**AGENDA**  
**COMMITTEE OF THE WHOLE MEETING**  
**MONDAY, OCTOBER 3, 2016**  
**NORTH AURORA VILLAGE HALL - 25 E. STATE ST.**  
(Immediately following the Village Board Meeting)

RE: Randall Oaks Concept Plan

After initial review of the proposed site concept plan for Randall Oaks, I offer the following preliminary comments:

**To:** Village President and Village Board of Trustees  
**From:** Steven Bosco, Village Administrator  
**Date:** 9-29-16  
**Re:** Parking on Elleby Court

*Proposed Residential Building*

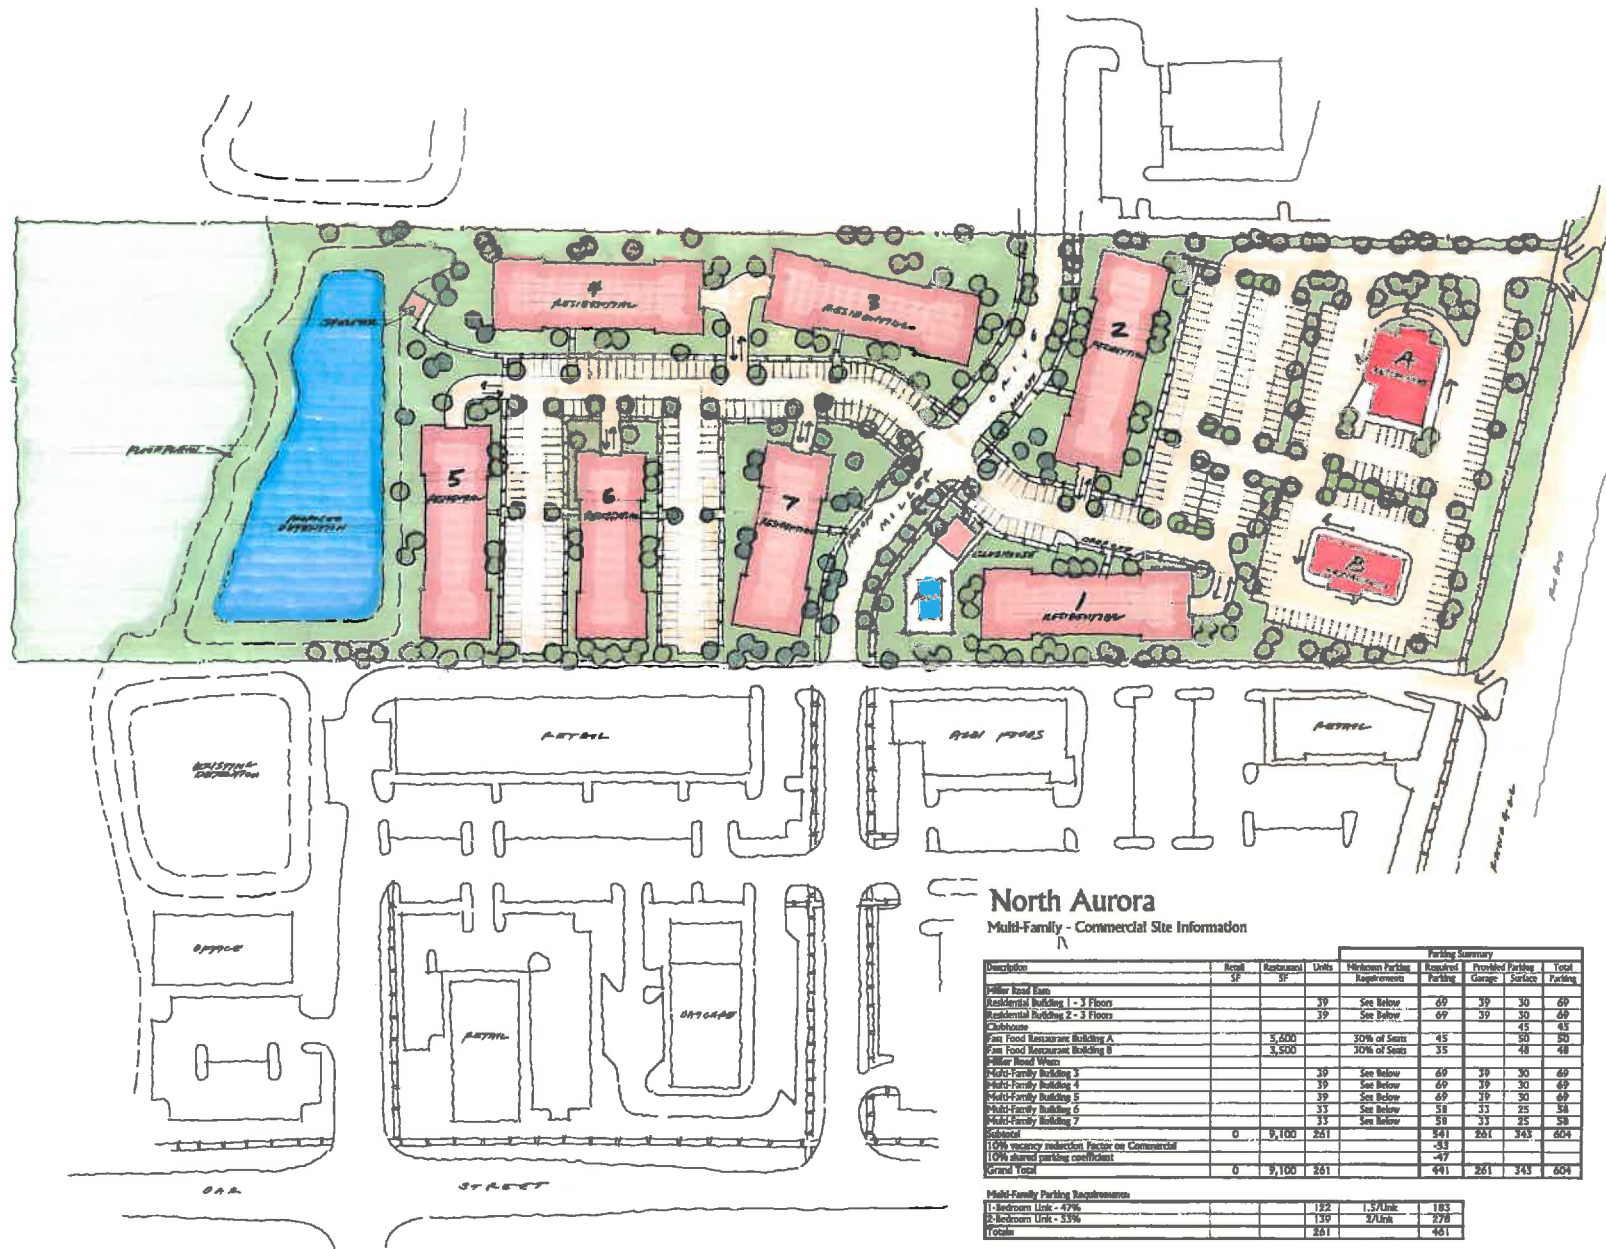
5. The proposed architecture of the buildings should be consistent and/or complimentary to the existing developments to the north and to the south. Examples of similar projects built by the developer were provided to show what the architecture might look like. The example provided appears to utilize high quality materials, a variety of materials including some masonry on the ground floor, and underground parking. Detailed architectural renderings should be provided.
